Addendum

RX2 Receiver

DIAGRAM 2 - RX2 New Wallplate Wiring

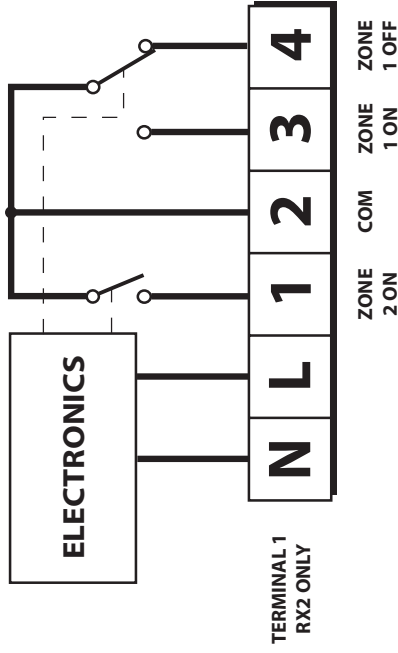
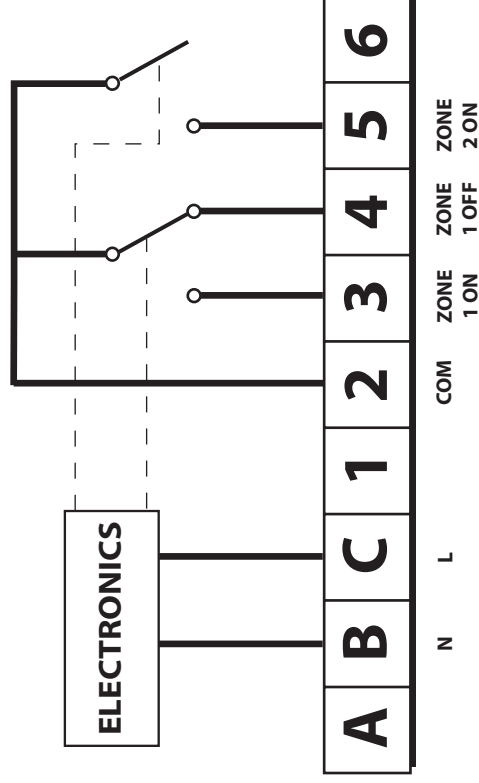
ATTENTION: This model of the Danfoss Randall RX2 Two Zone Wireless Receiver has a NEW (9 pin) design of wallplate, and is not compatible with the older (6 pin) style of wallplate.

Please ensure that before fitting the RX2 receiver unit the new wallplate has been fixed correctly and the wiring adheres to that shown in diagram 2 above.
